United States Patent and Trademark Office

APPLICATION NO.	FILING DATE	FIRST NAMED INVENTOR	ATTORNEY DOCKET NO.	CONFIRMATION NO.
10/772,372	02/06/2004	Tomohisa Kato	248601US3	6781
22850 - 759	90 07/14/2005		EXAMINER	
OBLON, SPIVAK, MCCLELLAND, MAIER & NEUSTADT, P.C.			ADDISU, SARA	
1940 DUKE ST ALEXANDRIA			ART UNIT	PAPER NUMBER
	,		3722	
			DATE MAILED: 07/14/2005

DETAILED ACTION

FIG. 4

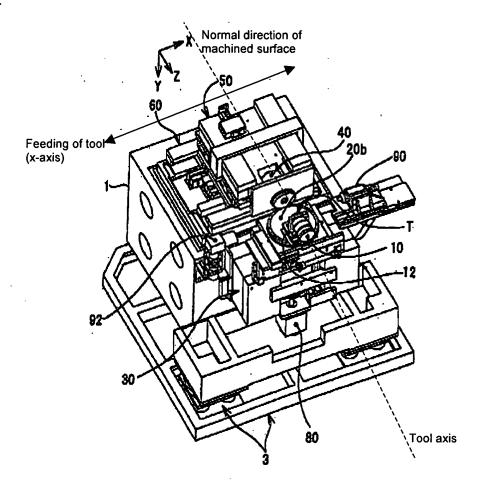
Inada et al. teaches a machine tool having a turntable (20b) mounted to rotate around a first rotating axis (B), tool holder mounted to rotate around an axis that is perpendicular to B-axis and a workpiece rotating around C-axis (which is perpendicular to B-axis). Inada et al. also teaches tool (T) being set such that it's machining (cutting) point (B), which is in line with it's rotational axis, coincides the B-axis (see figures 2C & 4 and Page 4, paragraph 67, lines 1-6). Furthermore, Inada et al. teaches X-axis moving unit (60), Y-axis moving unit (30: which is parallel to the rotational B-axis), a Zaxis moving unit (50) and fine adjustment mechanism (12). Inada et al. also teaches the moving units, the drive unit and the turning units being controlled such that the work point on the workpiece coincides with the machining point of the tool (i.e. is moved along the machined surface). Additionally, Inada et al. teaches the X-axis moving unit (60) producing relative movement between the work point (A) of the workpiece and the machining point (B) of the tool (page 4, paragraph 56, lines 1-5). This means the X-axis movement is the feeding direction of the tool, therefore the front rake surface of the tool is perpendicular to its feeding direction while coinciding with the tool axis (see diagram below).

However, Inada et al. fails to teach a rotary base mounted on the rotarty table (turntable) (20b) rotating around an axis that is perpendicular to both B-axis and tool rotating axis.
